APPEAL TO THE BOARD OF SUPERVISORS:
 VALADAO SUBDIVISION
 APPLICATION # PLN-2021-17560 (FILED 12/22/2021)
 — SEE ATTACHED —

Project Title: Valadao – Subdivision Appeal
Address: 1820 Pickett Rd., McKinleyville, CA 95519
Assessor’s Parcel # 510-381-021-000
Record Number: PLN-2021-17560-APPEAL
Board of Supervisors File Number: BAI-23-1593
planningclerk@co.humboldt.ca.us

Valadao Subdivision
1820 Pickett Rd. MCK
Parcel 510-381-021-000
PLN-2021-17560-APPEAL
BOS File BAI-23-1593

Exhibit VI

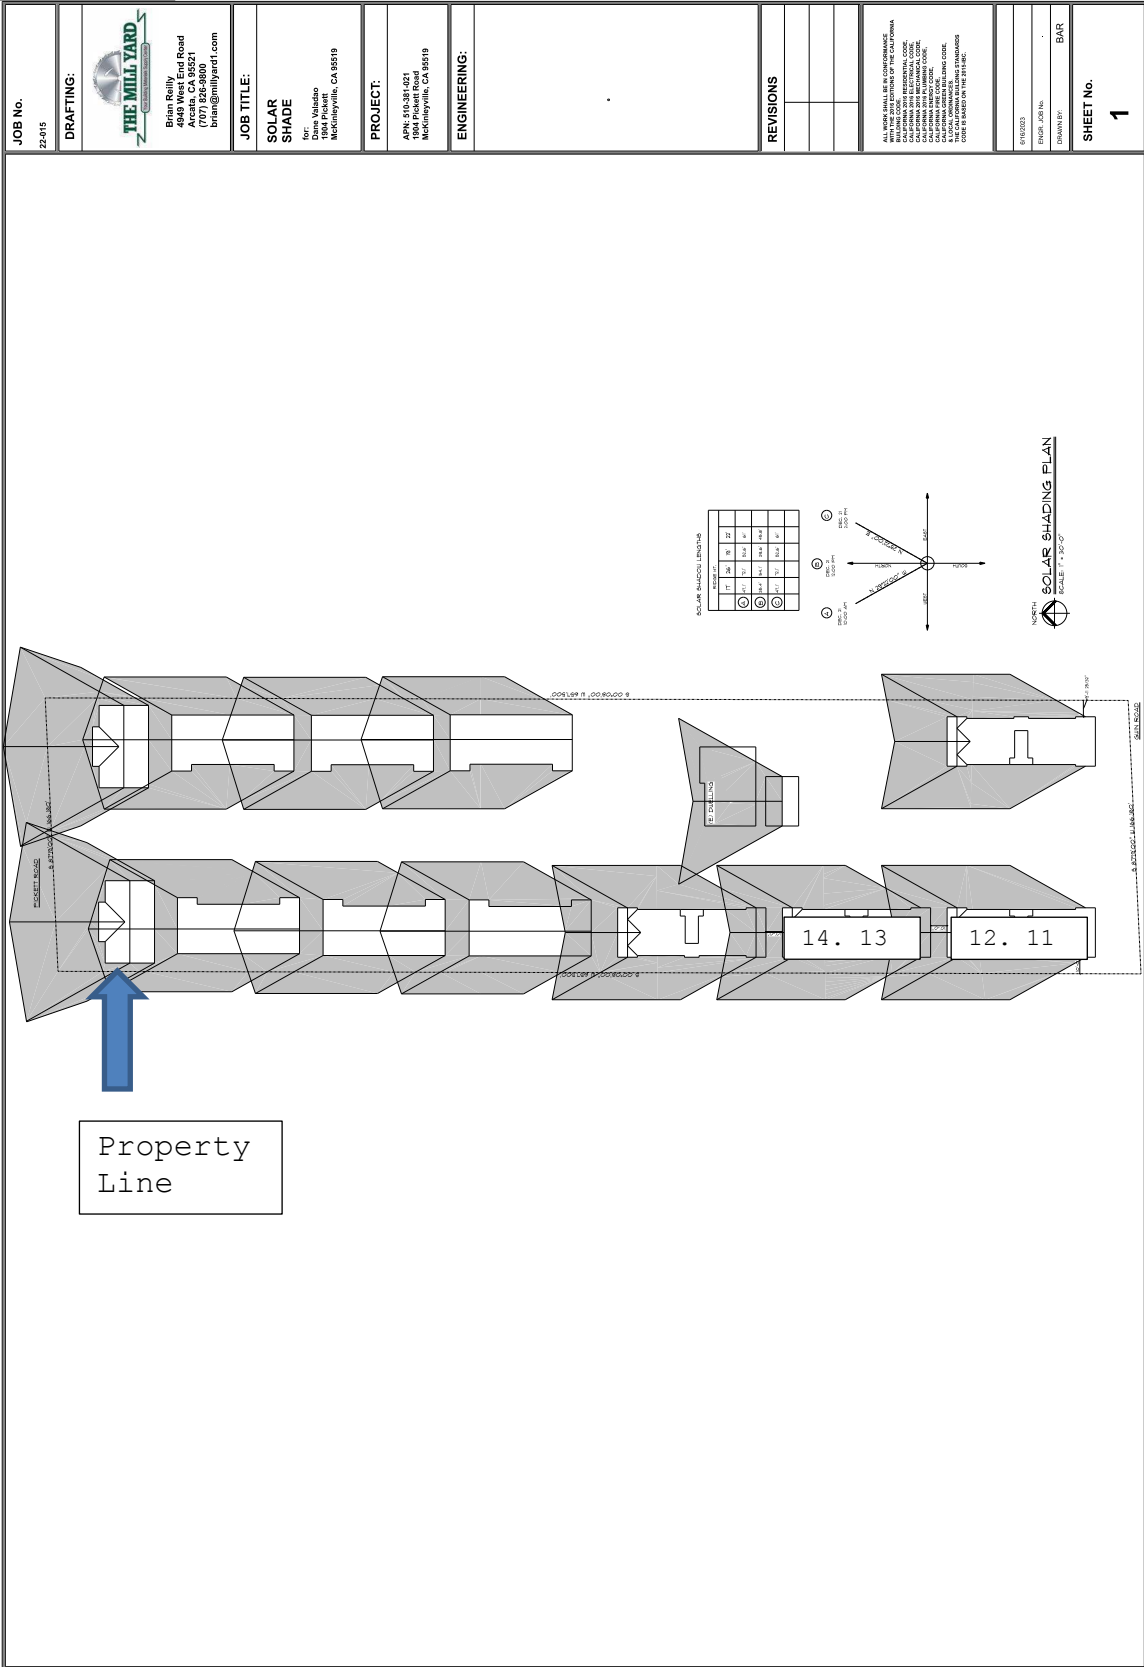
Given that the Applicant is proposing two-story buildings, and that the buildings are facing east, except for the existing house (Lot 8) and the initial buildings in each row of apartments (Lots 7, 10, and 11), it is mathematically impossible for the buildings to meet these requirements. The “Solar Shade Plan” Exhibit prepared by the Mill Yard proves this out.

However, once I pointed this out to the Planner, he said it was a “typo.” However, I suspect it was not a typo. The Planning Department Draft Resolution states that “The applicant has prepared a Solar Shading Study *and found (emphasis added)* that all new parcels will comply with the County's Solar Shading Ordinance....” First, an applicant cannot both prepare the study and approve its findings. It is up to the Planning Department to review the study and agree with its findings. Second, unless there is some other “Study” besides the “Solar Shade Plan” posted on the Department website, the Plan shows almost all buildings are completely in the shade during the time

3. Because, per the Solar Shade Plan, the two-story buildings will shade 15’ of each of the 15 manufactured homes adjacent to them—all day long.
4. Because, of that shade, those 15 residents of the manufactured home park will be cold and, therefore, have higher heating cost.
